Roosevelt Lofts – Historic Rehabilitation & New Apartments – 22-3281

ADDENDUM NO. 1

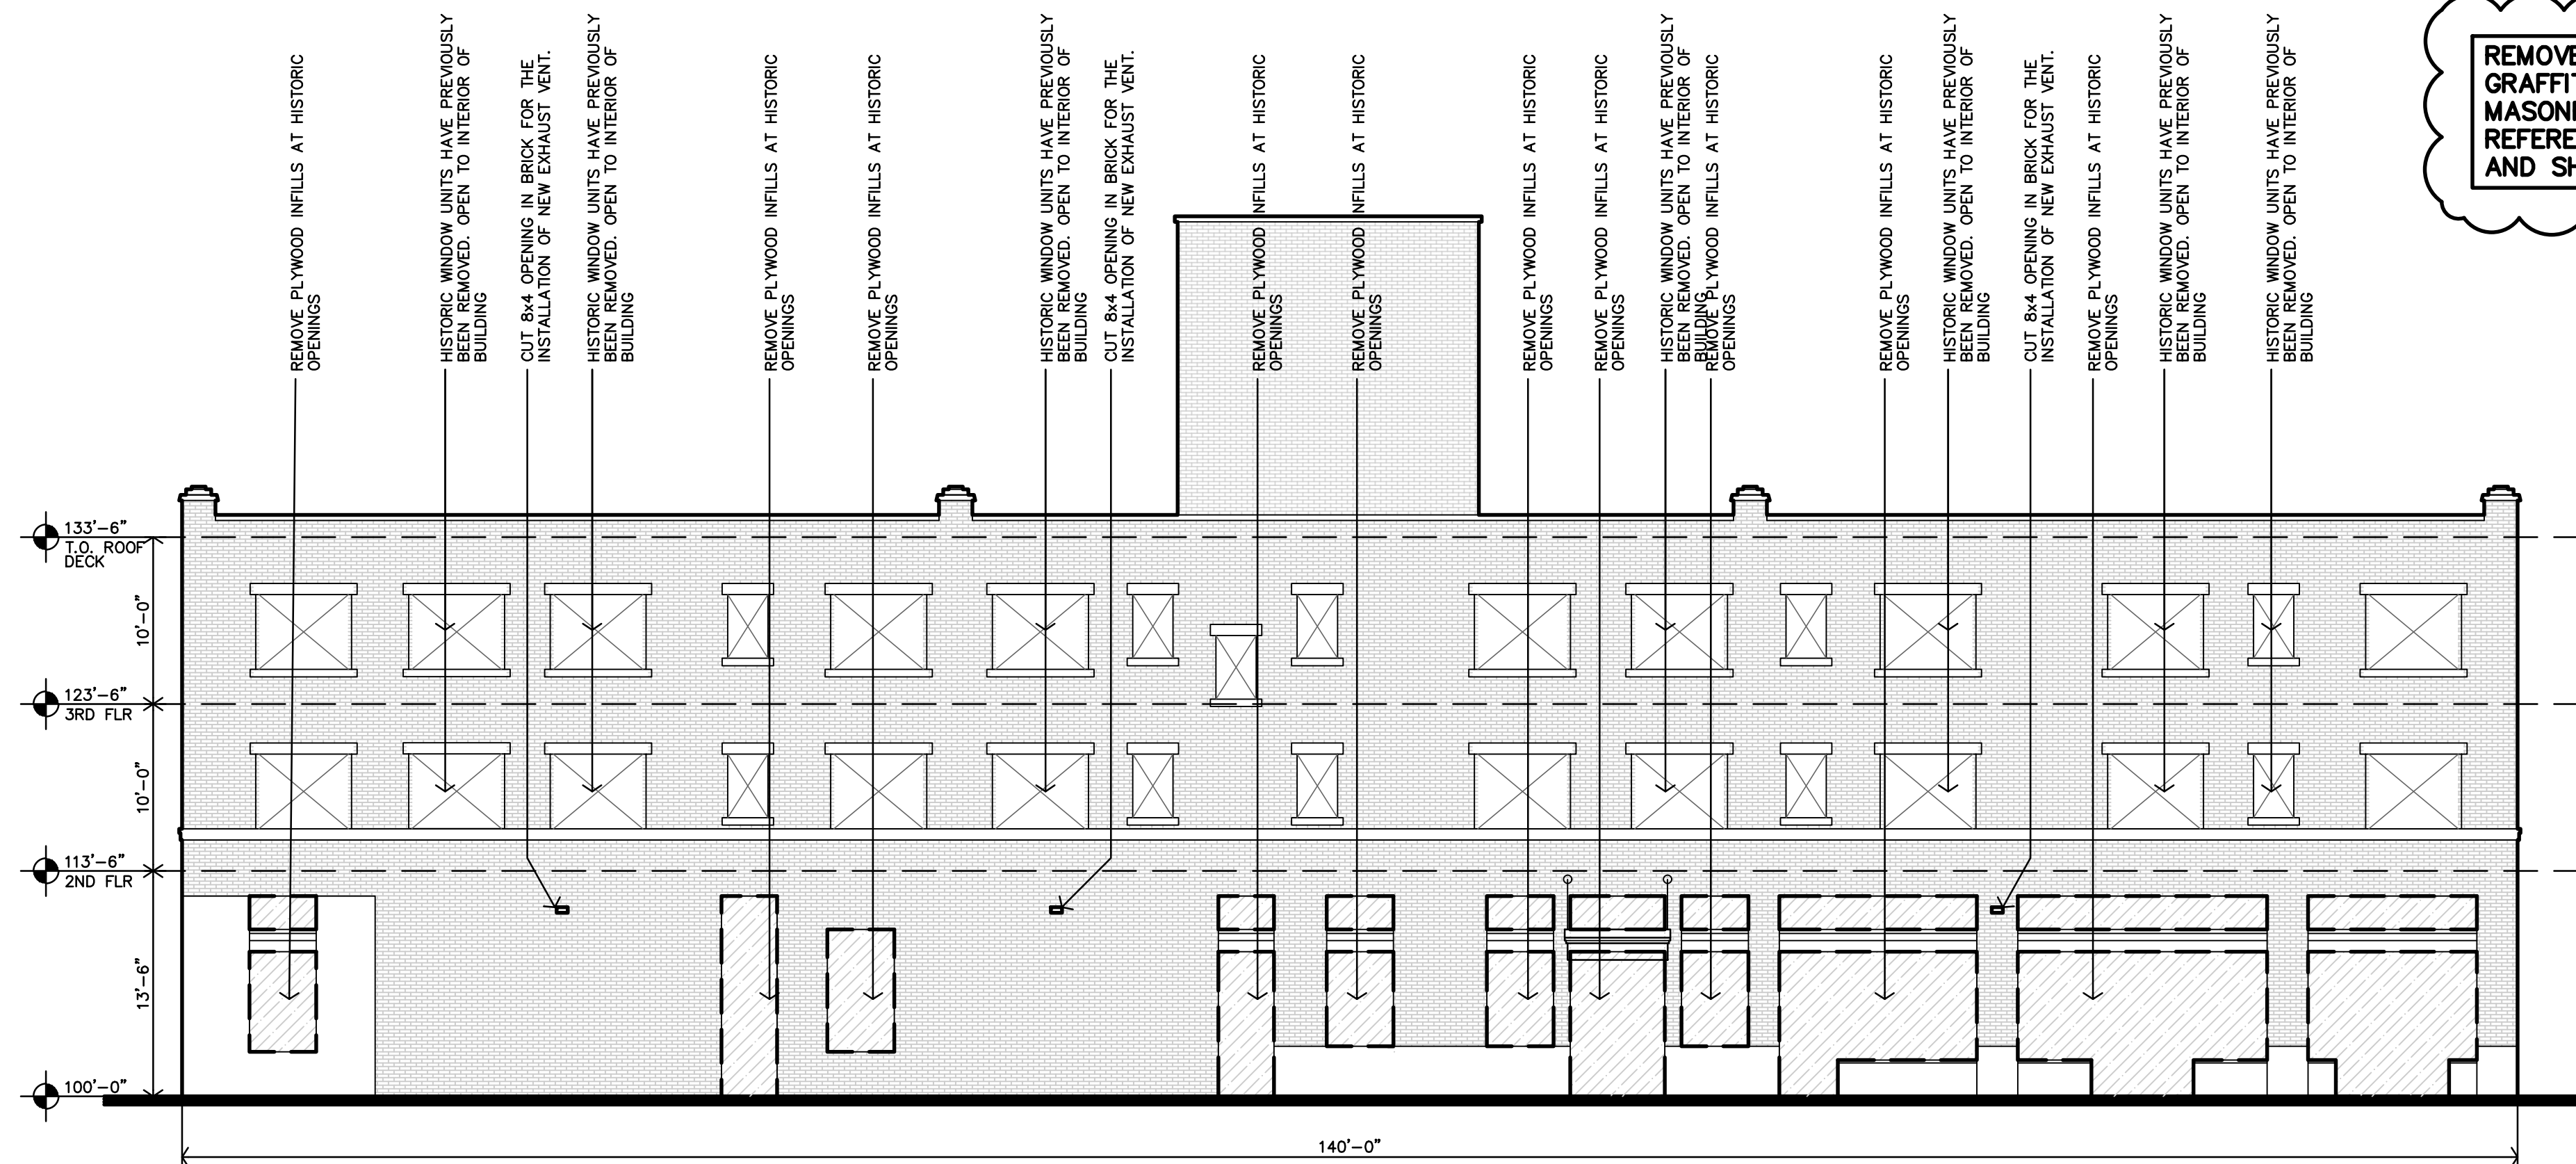
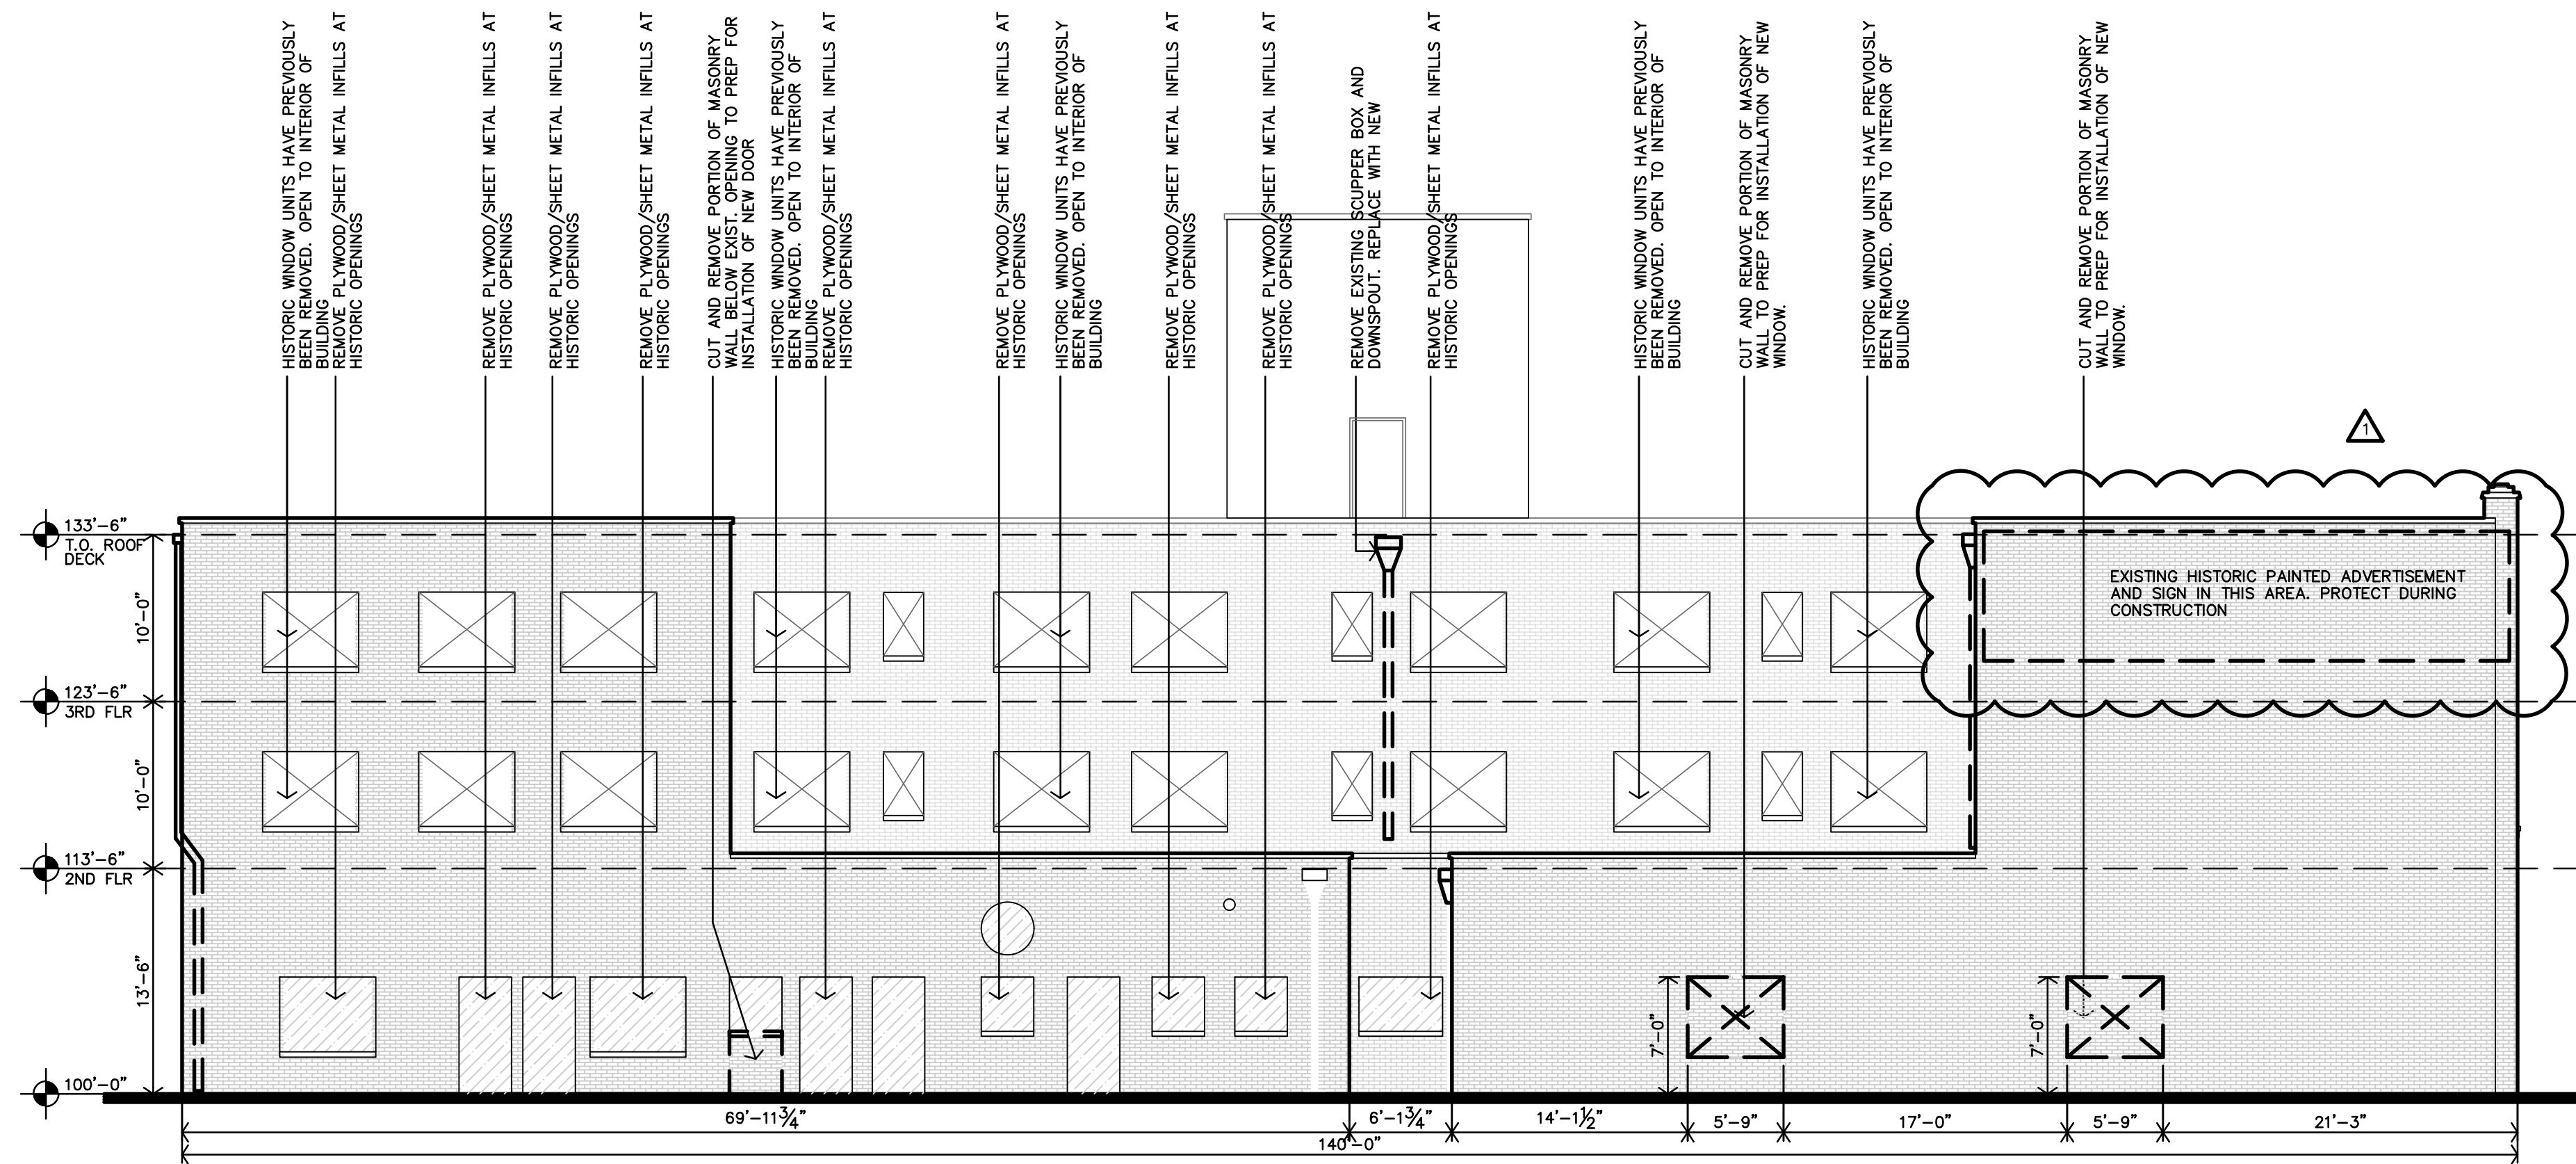
2. Sheet D3.1
 - a. Added Note to sheet: Remove any and all Graffiti from exterior masonry and stone. Reference Specifications and Sheet A3.2 for notes.

- b. Detail D – Added Note: Existing Historic painted advertisement and sign in this area. Protect during construction.
3. Sheet D3.2 – Added Note to sheet: Remove any and all Graffiti from exterior masonry and stone. Reference Specifications and Sheet A3.2 for notes.
